I-90 ALLSTON INTERCHANGE A MULTIMODAL TRANSPORTATION PROJECT THROAT AREA/CHARLES RIVER WORKING GROUP July 9, 2024

Option 1 - What We Heard

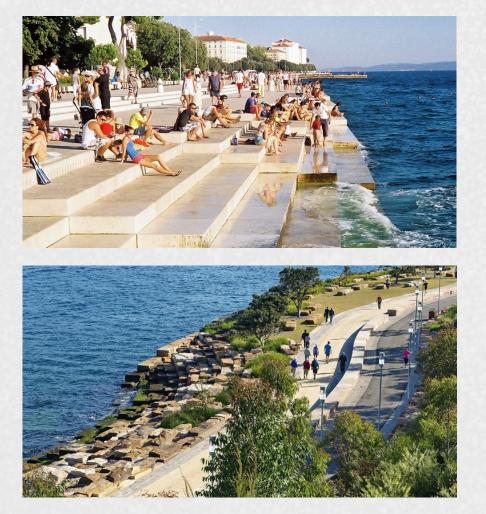
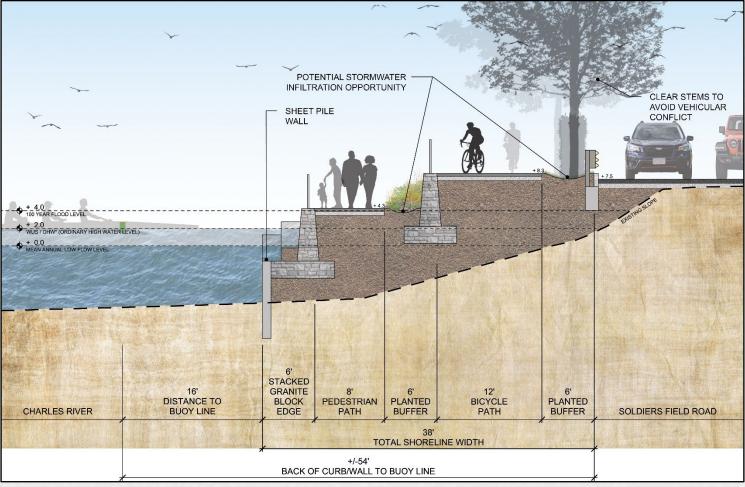
- Vertical Wall
 - creates significant wave deflection concerns (River Users)
 - provides no opportunities for river user respite or rescue (River Users)
 - provides little to no ecological value (River Users & Permitting Agencies)
- Significant river impact due to maximized fill (Permitting Agencies)
- Provides most easily maintained shoreline treatment (DCR)
- Allows for healthy and maintainable planting buffers at path edges (DCR)
- Road traffic will be loud and uninviting (River Users)

- Explore option to improve river's edge treatment to reduce wave deflection and provide areas of respite
- To maintain ease of maintenance access, unlikely to be able to provide a planted river's edge without increasing volume of river fill (which is already maximized).
- Consider opportunities to reduce traffic noise

Option 2 - What We Heard

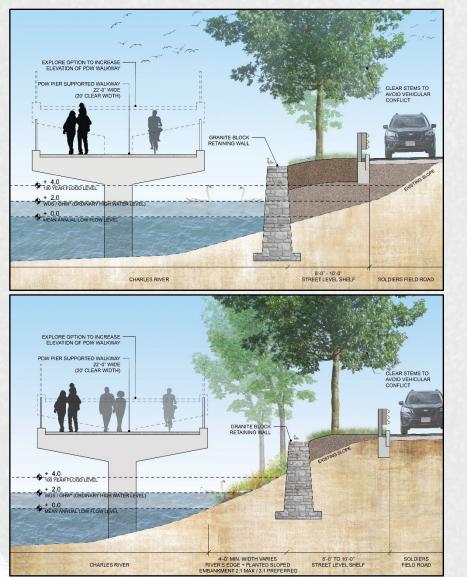
- Raised Walkway in river reduces usable water sheet and presents a safety issue for river users (i.e. navigation obstacle and head height concern) (River Users)
- Raised Walkway inhibits access to shoreline from watersheet (River Users & DCR)
- While the planted shoreline is desirable, it is limited in length and narrow (River Users)
- Challenging planting environment on north facing slope (*River Users & DCR*)
 Significant river impact due to fill (*Permitting Agencies*)
- Shoreline is inaccessible for maintenance purposes (DCR)
- Planted terraces and range of conditions are difficult to maintain (DCR)
- Pile Supported Walkway is difficult to maintain and plow (DCR)
- Safety concerns if disconnected from land (River Users)
- Potentially improve parkway experience (MassDOT & DCR)

- Explore option to increase height of walkway to reduce head height concerns
- Reduce number of pile supports to lessen conflicts on water sheet (i.e. explore a mono pier type structure)
- Even if raised, conflicts at landing points remain •
- Unlikely to be able to improve DCR's maintenance access concerns

Option 3 - What We Heard

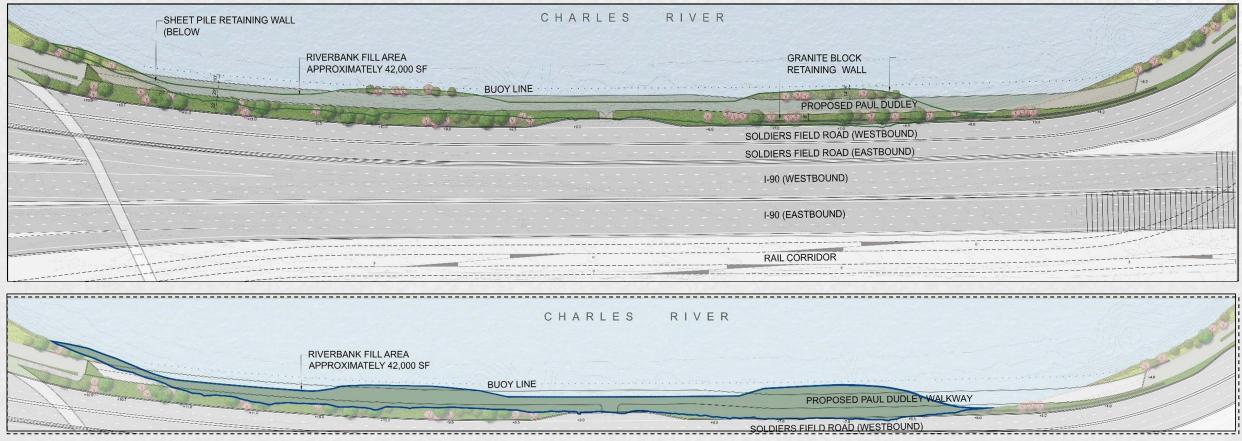
- Consider opportunities to expand locations of shoreline to improve river user's ability to pull up along land (MassDOT & River Users)
- Provides some ecological value but not extensive (River Users) •
- Number of different planting conditions for at-grade portion could be reduced to improve ease of maintenance (*DCR*)
- Raised Walkway presents same challenges as other options (River Users & DCR)
- Significant river impact due to maximized fill (Permitting Agencies)
- Potentially provides some desirable stormwater infiltration opportunities (DCR & Permitting Agencies)
 Road traffic might be loud and uninviting at some locations
- (River Users)

- Explore options to better distribute locations of planted shoreline to improve river user's experience
- Cannot increase planted shoreline length without increasing river fill.
- Potential to reduce number of different planting conditions to improve ease of maintenance
- Explore opportunities to reduce wave deflection
- Consider opportunities to reduce traffic noise

Option 4 - What We Heard

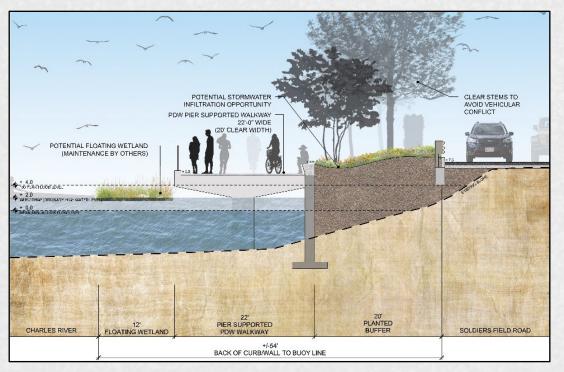
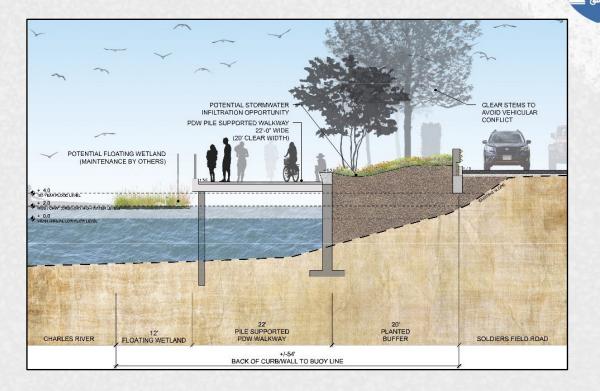
- Vertical Wall
 - creates significant wave deflection concerns (River Users)
 - provides no opportunities for river user respite or rescue (River Users)
 - provides little to no ecological value (River Users & Permitting Agencies)
- Raised Walkway in river reduces usable water sheet and presents a safety issue for river users (i.e. navigation obstacle and head height concern) (*River Users*)
- Reduced river fill is desirable (Permitting Agencies)
- Provides a more easily maintained planting area and walkway (DCR)
- Potentially provides some desirable stormwater infiltration opportunities
 (DCR & Permitting Agencies)
- Provides minimal ecological benefit at river's edge (*River Users and Permitting Agencies*)
- Road traffic will be loud and uninviting (River Users)

- Explore option to improve river's edge treatment to reduce wave deflection and provide areas of respite
- Reduce number of pile supports to lessen conflicts on water sheet (i.e. explore a mono pier type structure)
- This option includes a walkway structure fixed to land (as opposed to Option 2) to promote utility/drainage design efficiency. Raising walkway could be explored however
- Even if raised, conflicts at landing points remain
- Consider opportunities to reduce traffic noise
